Darden Clean Energy Project (23-OPT-02)

CEC Data Request Response Set #3

April 2024

Figure 1 Emergency Backup Generator Modeling Locations

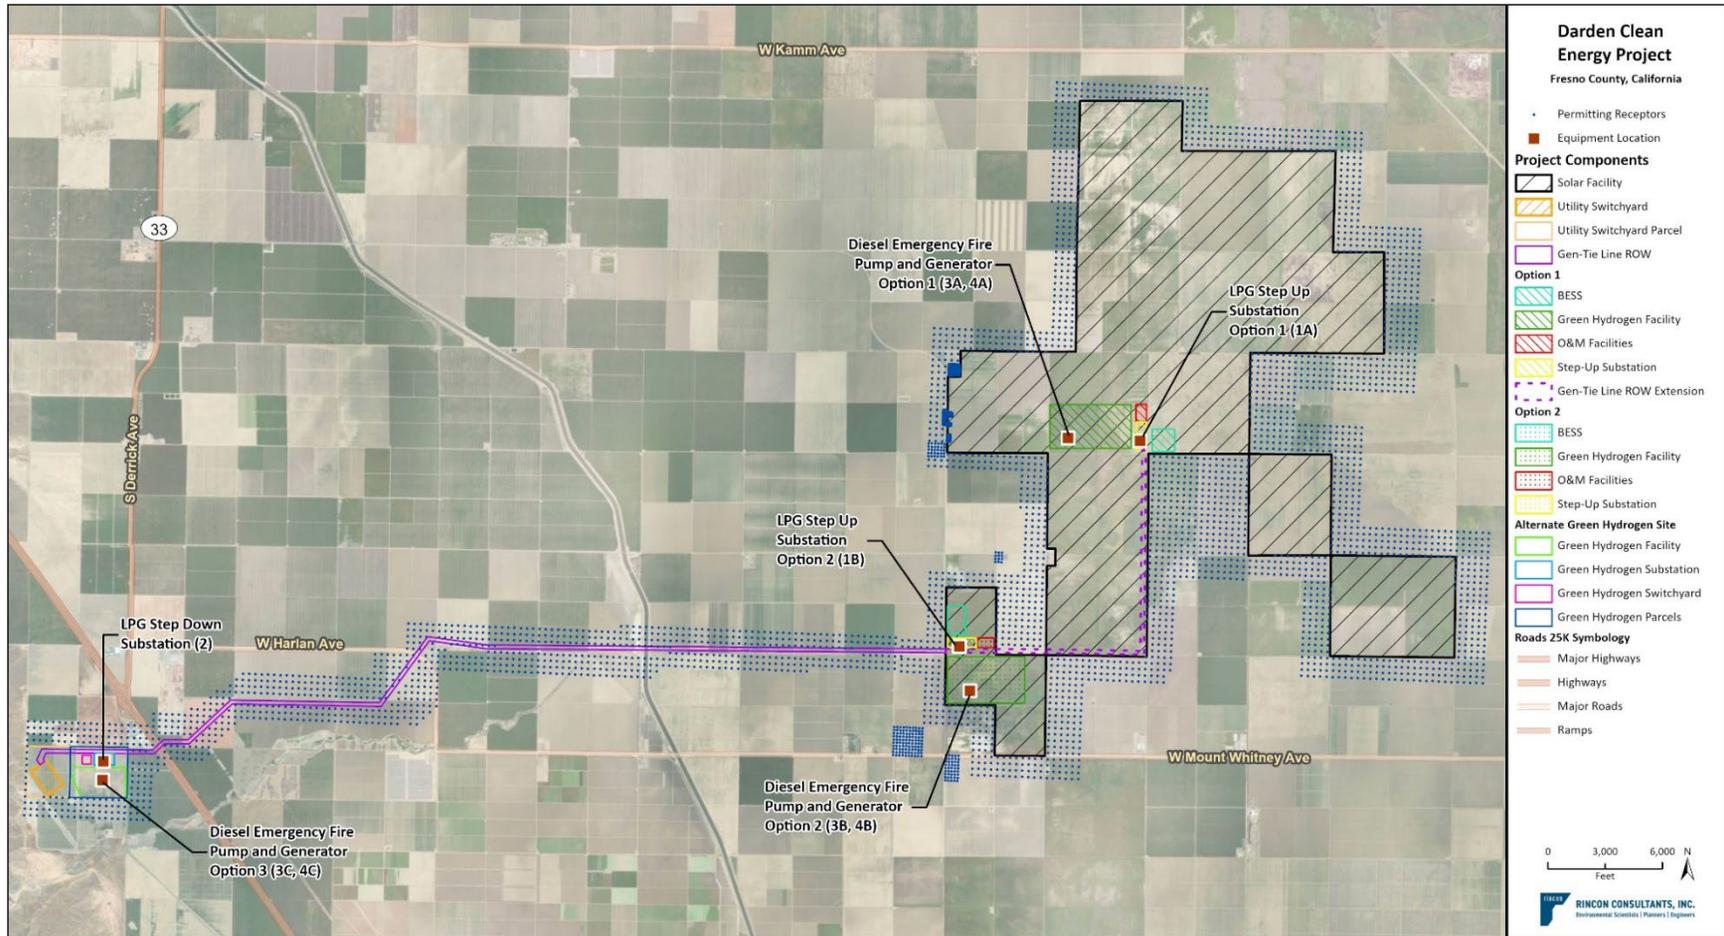
DR AQ-12: Please provide the proposed locations of all backup generators and provide the modeling results for readiness testing and maintenance at each location by treating them as point sources instead of multiplying their emissions by the area source results.

DR PH-5: Please provide the proposed point source locations of all backup generators and provide the modeling results of diesel PM from readiness testing and maintenance operations by treating the stationary sources as point sources at each of the proposed locations.

Response: Specific locations for each backup generator will be finalized in later stages of engineering and design. Prospective locations of all backup generators for each of the potential Project design scenarios (i.e., Option 1, Option 2, and Alternate Green Hydrogen Site) are depicted in Figure 1. The equipment was assumed to be centrally located in each project area (i.e. near the center of each proposed Green Hydrogen site), as it was determined that the equipment would be unlikely to be located near project and/or fenceline boundaries. There are multiple pieces of diesel equipment expected for each of the potential hydrogen facility design scenarios; however, as specific individual locations are not yet known, all units for each Project design scenario were collocated at a single point for the purposes of air dispersion modeling. Point source air dispersion modeling for readiness testing and maintenance was conducted at each location. The results of the modeling are provided in Appendix C of Appendix A.

Response: The proposed locations of all backup generators for each of the potential Project design scenarios are described in the response to DR AQ-12 and depicted in Figure 1. Point source air dispersion modeling for readiness testing and maintenance was conducted at each location. The results of the modeling are provided in Appendix C to Appendix A.
